Re: 3614, 3630 Colonel Talbot Road and 6621 Pack Road: Subject Lands Status Report Agency Comments Responses

Colonel Talbot Property, Residential Development
Agency Comments and Responses

Draft Subject Land Status Report (SLSR) – NRSI, November 2016

Draft Subject Land Status Report (SLSR) – NRSI, September 2017

Col. Talbot Wetland Areas

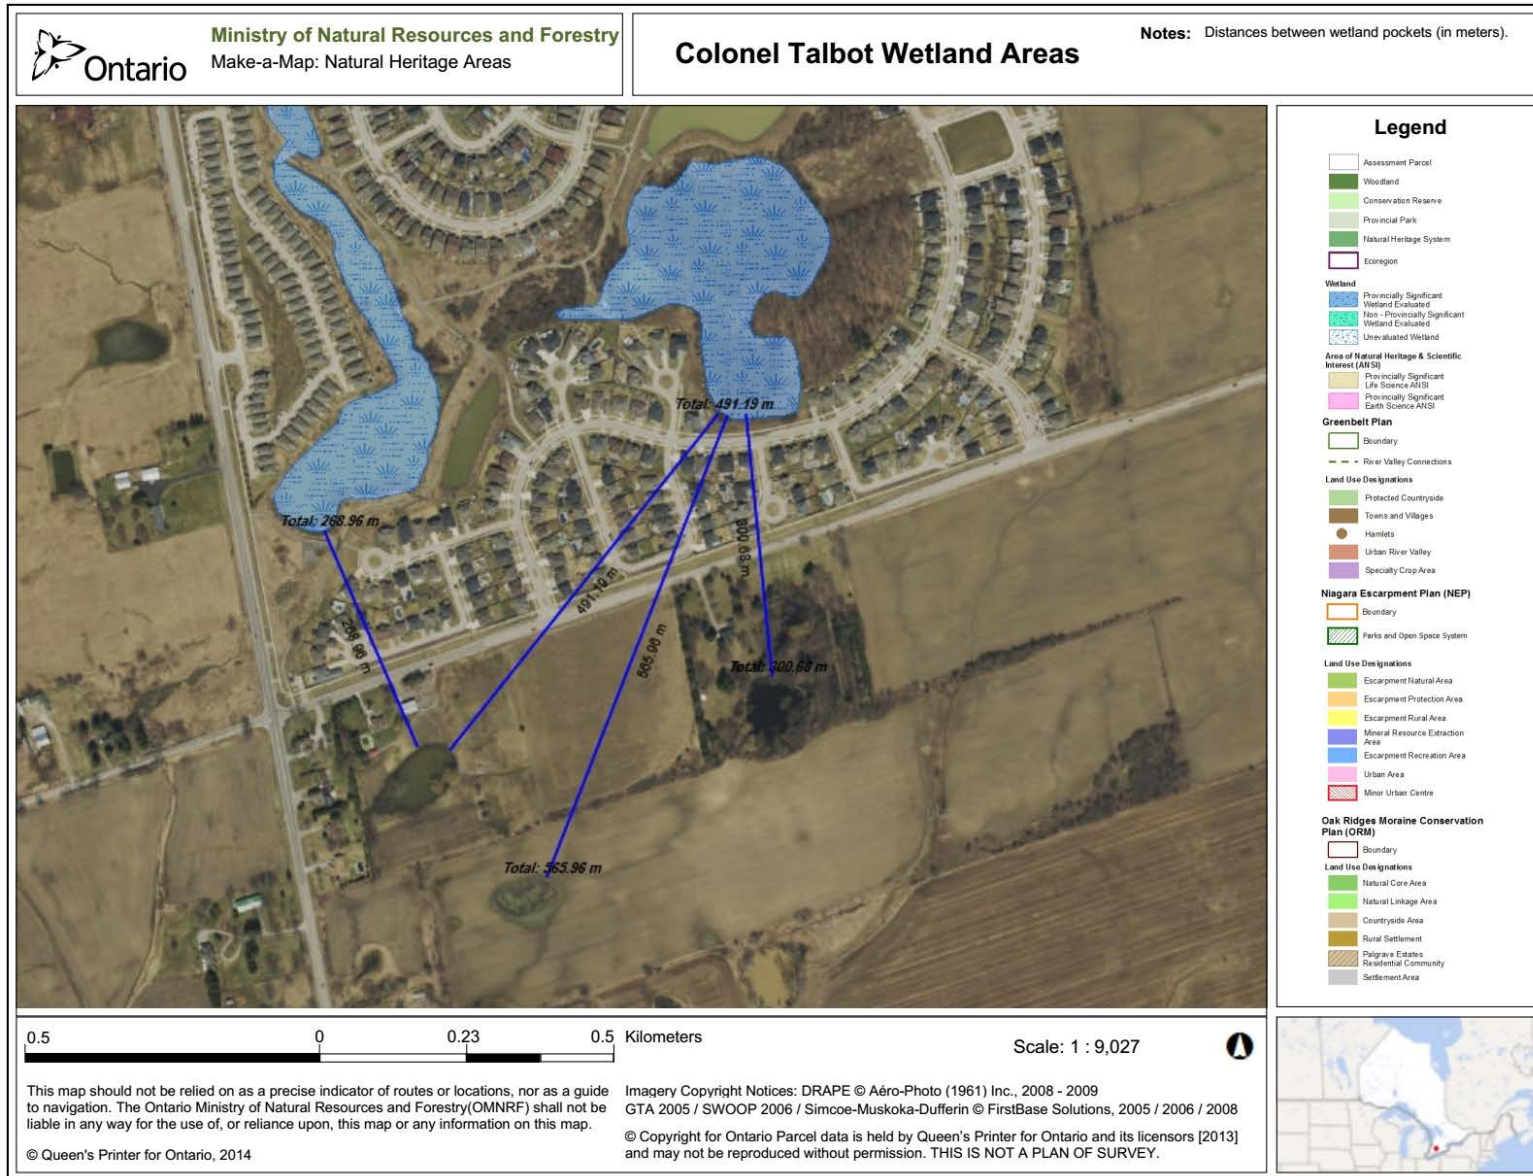
RE. UTRCA Comment 6.0(b):

- Distance between wetland units on and adjacent to subject property and the North Talbot Wetlands PSW units
